Delegated Report		Analysis sheet	Expiry Date:	16/10/2019
		N/A	Consultation Expiry Date:	13/10/2019
Officer			Application Number(s)	
David Peres Da Costa			2019/4295/P	
Application Address			Drawing Numbers	
10 Belsize Park Mews London NW3 5BL			Refer to draft decision notice	
PO 3/4	Area Team Signature	C&UD	Authorised Officer Signature	
Proposal(s)				
Erection of single storey conservatory at ground floor with rear terrace, following demolition of existing rear addition; sheer storey roof extension at second floor level; replacement of plastic cladding with white render to front and rear; conversion of garage to habitable room including replacement of door with wall and window; erection of bin store.				
Recommendation(s):		Refuse planning permission		
Application Type:		Householder Application

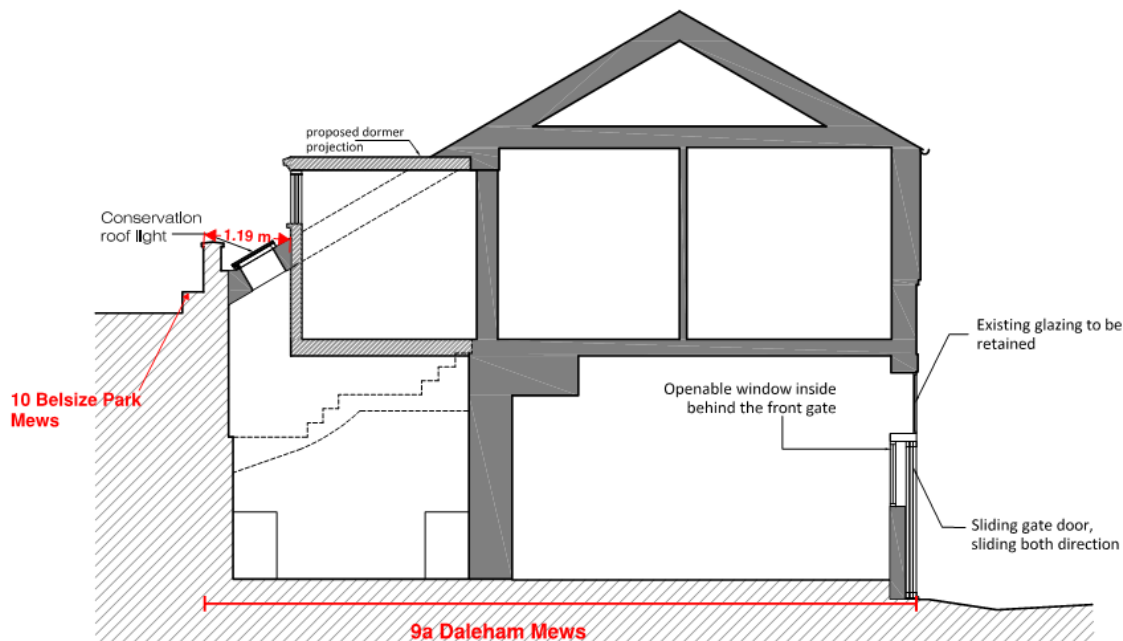
2.17 The neighbouring property immediately to the west, 9a Daleham Mews, has permission (ref: 2018/3539/P dated 05/03/2019) for dormer windows which would be within 1m of the boundary with the subject property (the dormers have not been built as yet). The approved dormers are shown on the plan below (marked D); the plan shows the close relationship between 9A Daleham Mews and 10 Belsize Park Mews.

2.18 The amount of daylight reaching the approved northern dormer window (which would serve a study) would be significantly reduced. The approved dormer window to the south (which would serve a bedroom) would only be partially blocked by the proposed extension and so it is unclear whether this window would receive enough daylight. Therefore, in the absence of a daylight and sunlight assessment, the applicant has not demonstrated that daylight and sunlight levels would not be harmed.
